Recommendation on electronic chart display and information system for inland navigation (resolution No. 48, revision 3)

Amendments to the Recommendation on electronic chart display and information system for inland navigation (resolution No. 48, revision 3) (ECE/TRANS/SC.3/WP.3/2019/7)

Transmitted by the Government of the Russian Federation

B. Section 4B: System Configurations (Figures)

Figure 1

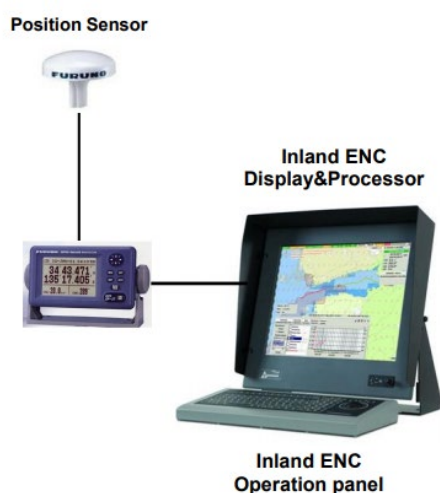
Modify figures 1–4 as follows

It is therefore proposed to complement the existing figures with AIS mobile station (transponder) as an external sensor.
